ADDENDUM NO. 2

Contract No. 2023-0050
Project Southeast Municipal Complex

Date of Issuance 09/19/2024

ROOF FRAMING PLAN

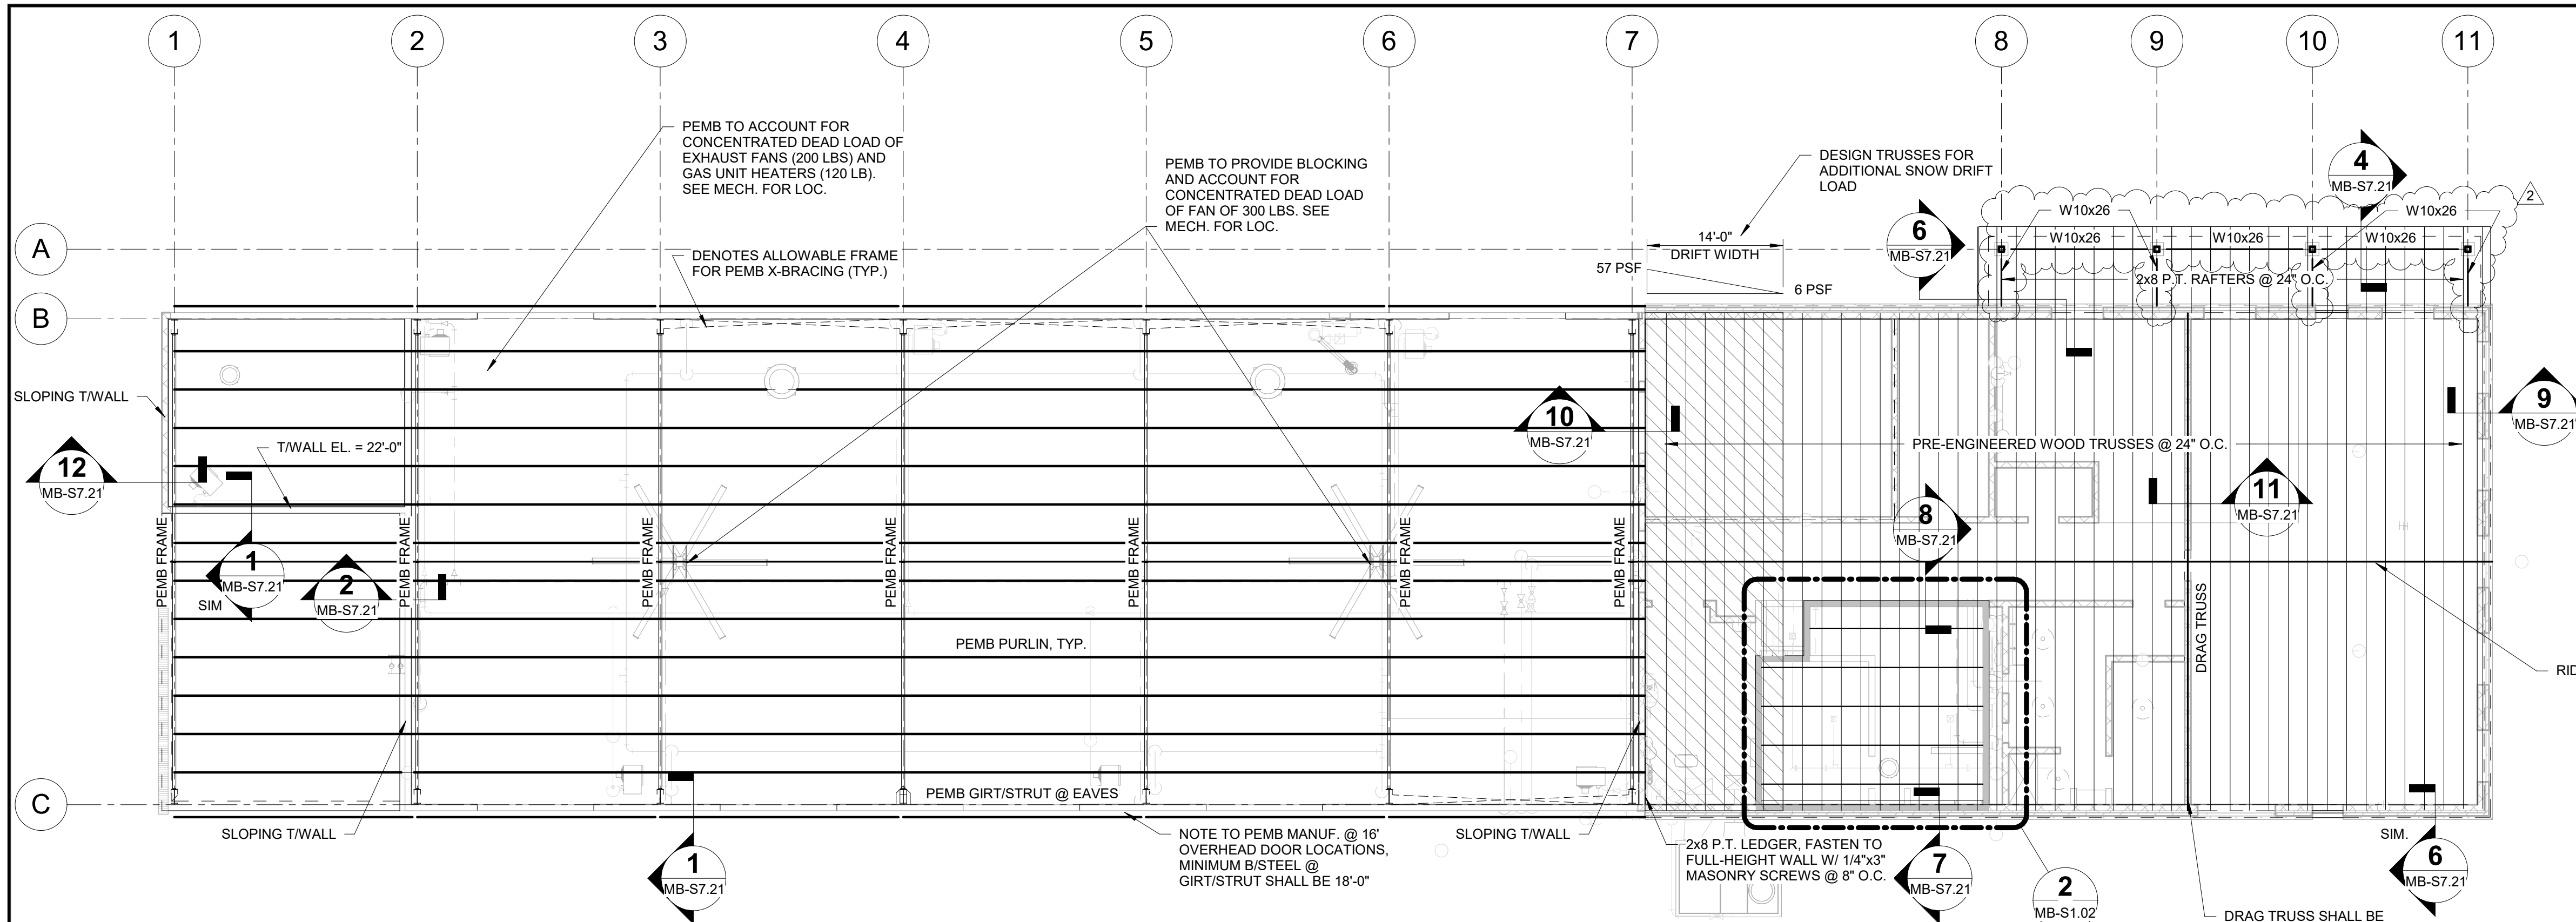
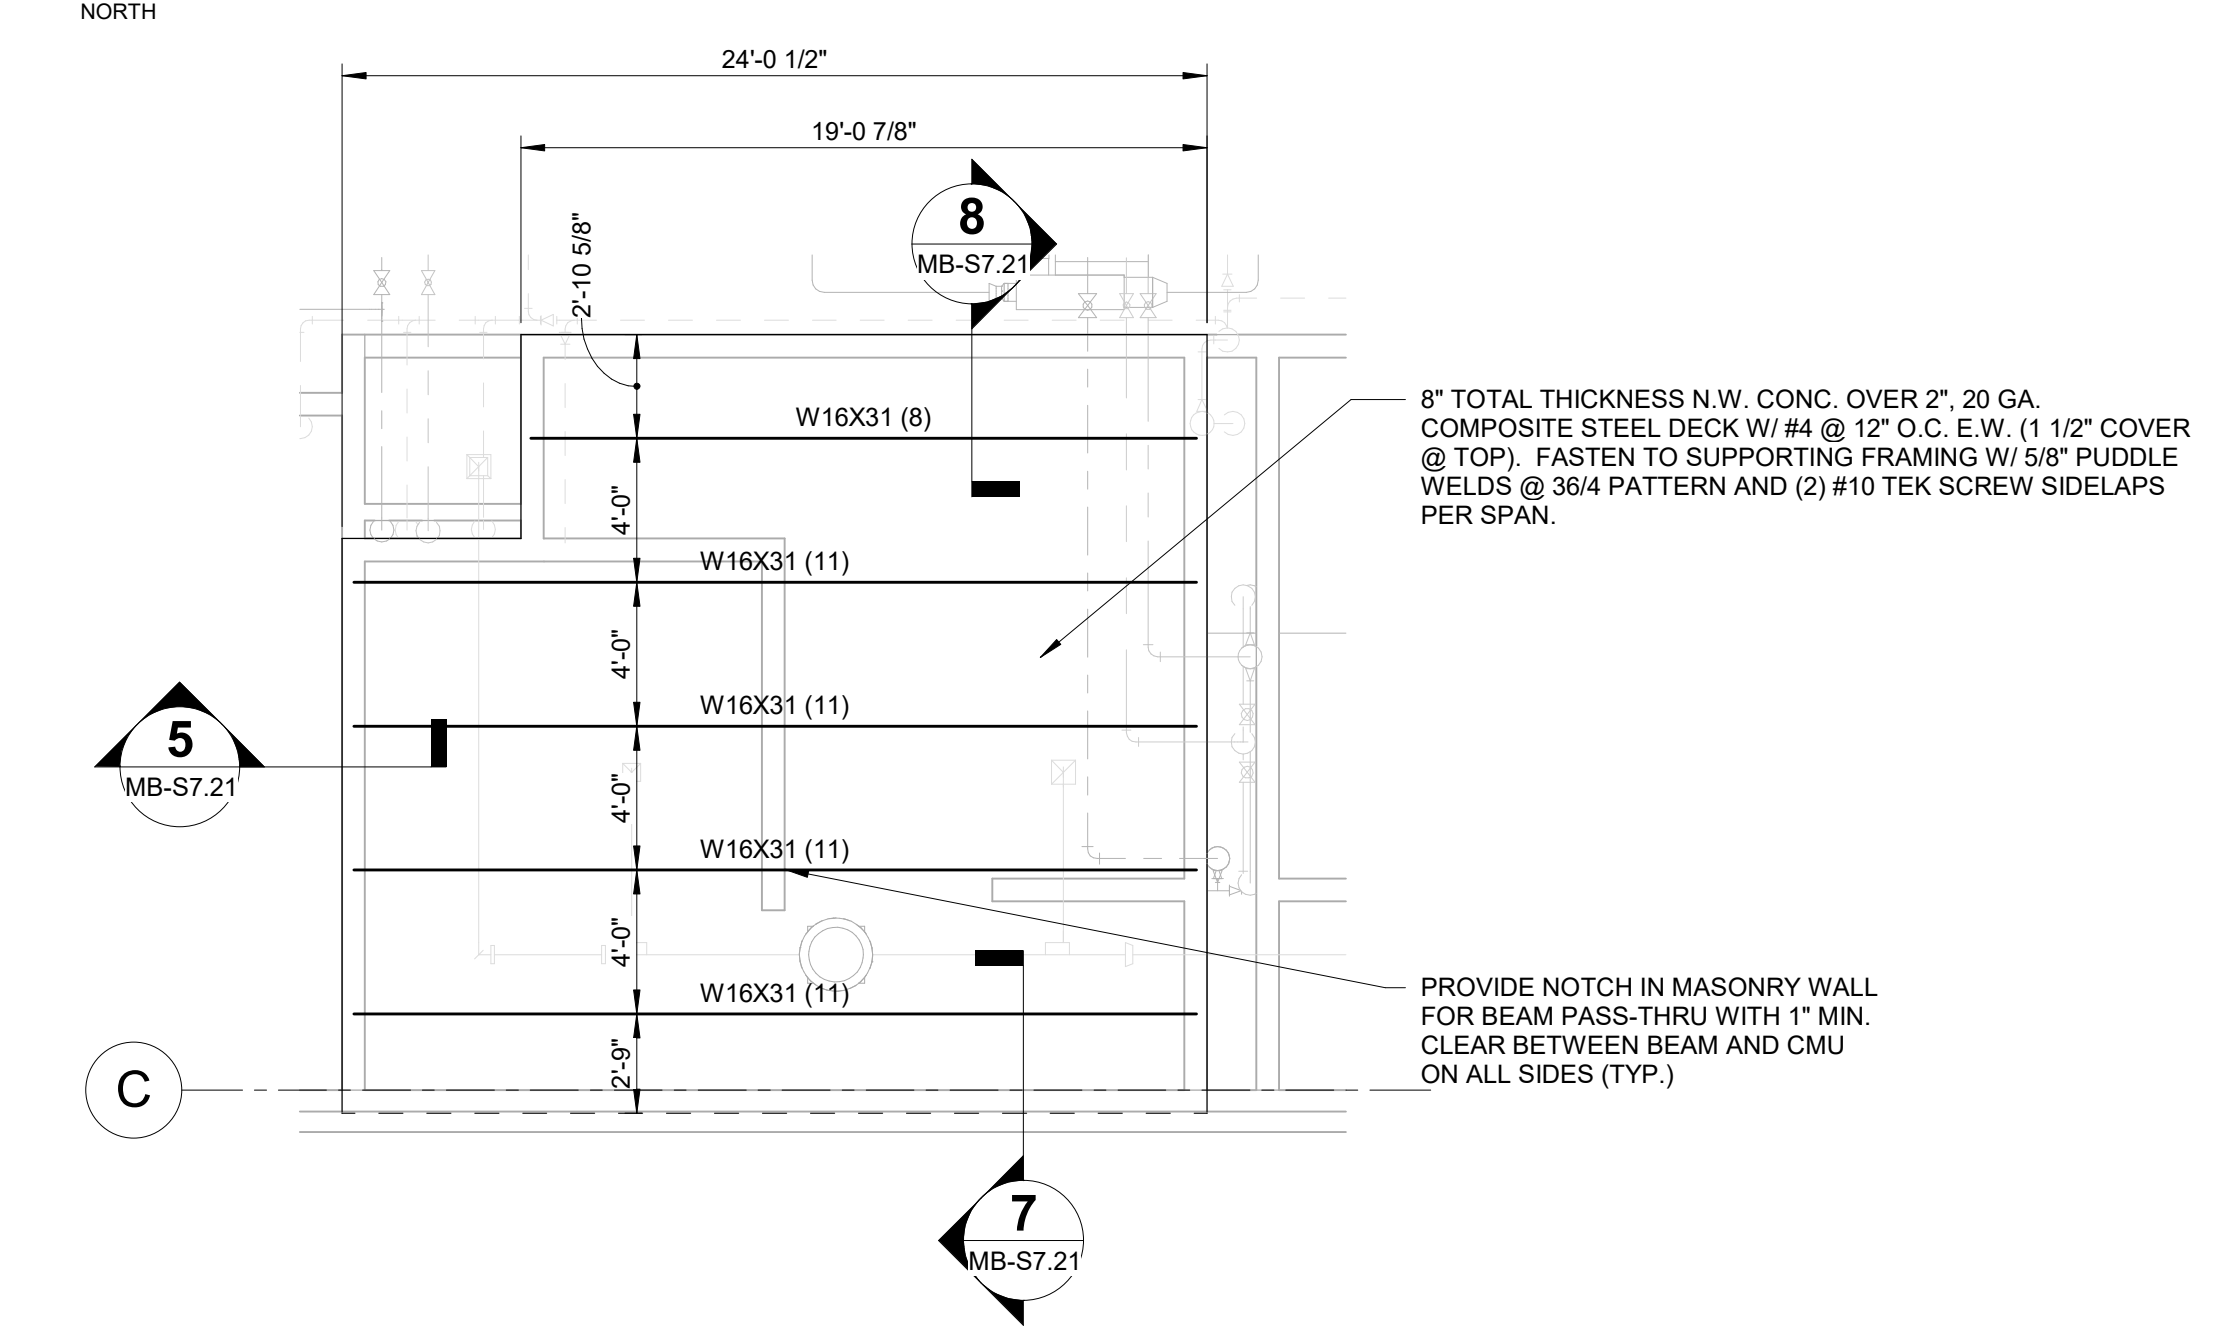
- j. Plan Drawing **MB-S1.02, Roof Framing Plan**, for the **Maintenance Building** has been updated and provided as **Attachment J** in response to Question 16.
